Regulation No. 41 (Noise emissions of motorcycles): Development

Proposal for amendments to the 04 series of amendments to Regulation No. 41

Submitted by the expert from International Motorcycle Manufacturers Association*

Figure 1
 Engine speed (calculation vs. measurement) – Class III MT ASEP

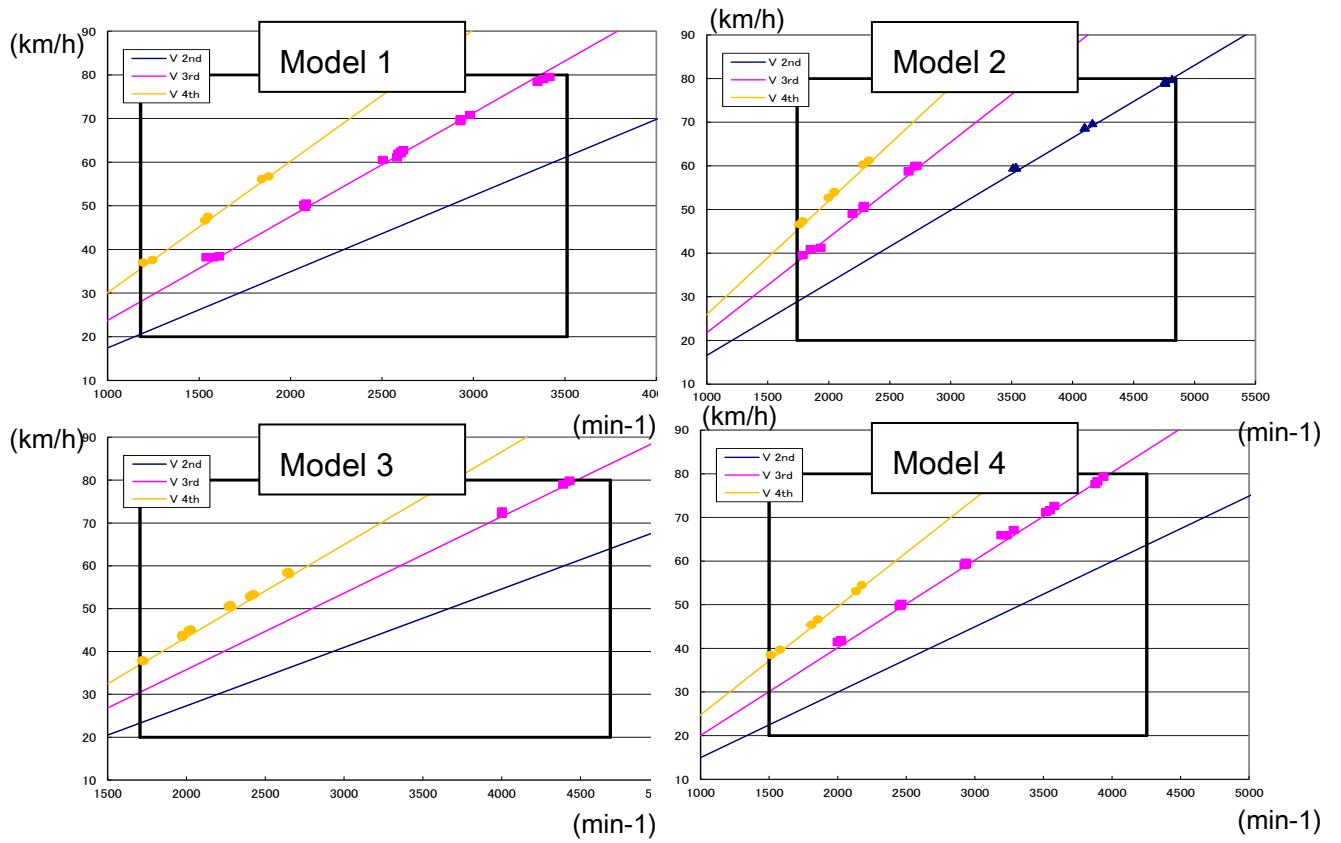
Under the current 04 series of amendments to UN Regulation No. 41, the engine speed should be measured during all tests in Annex 3 and Annex 7 (Additional sound emission provisions - ASEP). However, IMMA has checked and found that there is very little difference between the measured and the calculated engine speed for a MT vehicle (Annex, figure 1). IMMA has also found that this difference has no influence on the test result (Annex, figure 2). Based on these findings, IMMA proposes that the calculated engine speed for a MT vehicle and CVT/AT with rocked gear mechanism be additionally introduced into UN Regulation No. 41.

Figure 2
Engine speed (calculation vs. measurement) - Class III MT ASEP

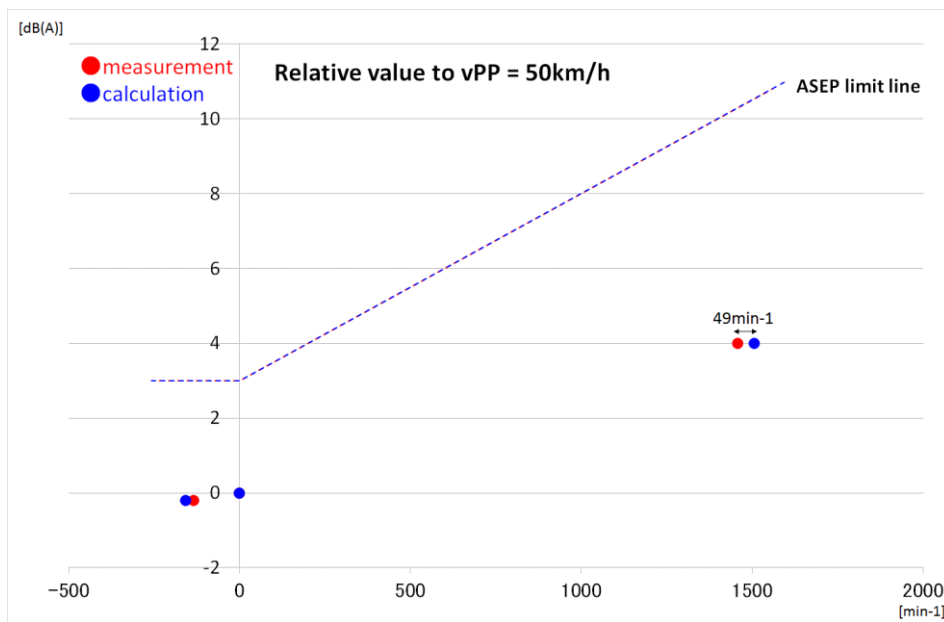
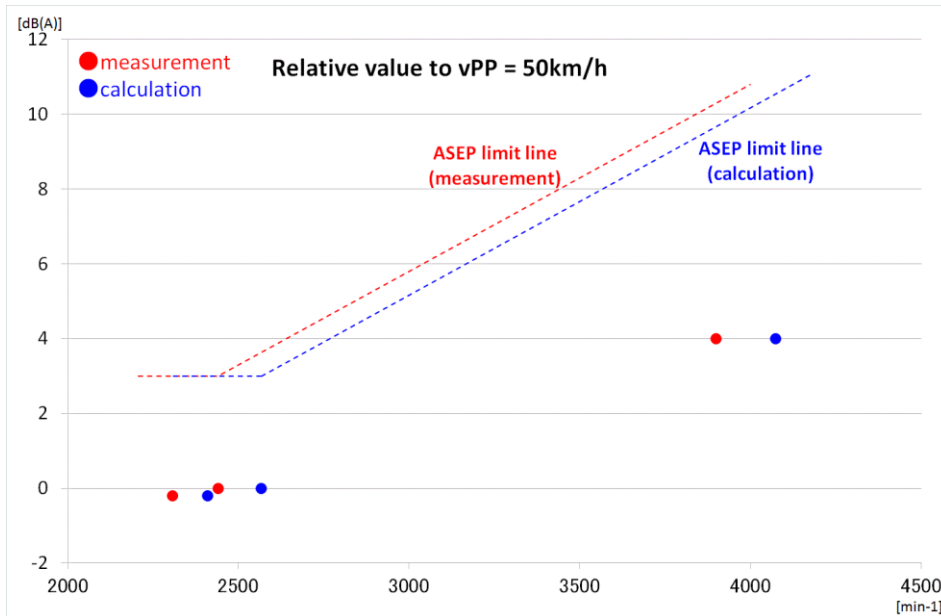
The difference is minor if data points of the measured speed and the calculated speed nearly overlap.
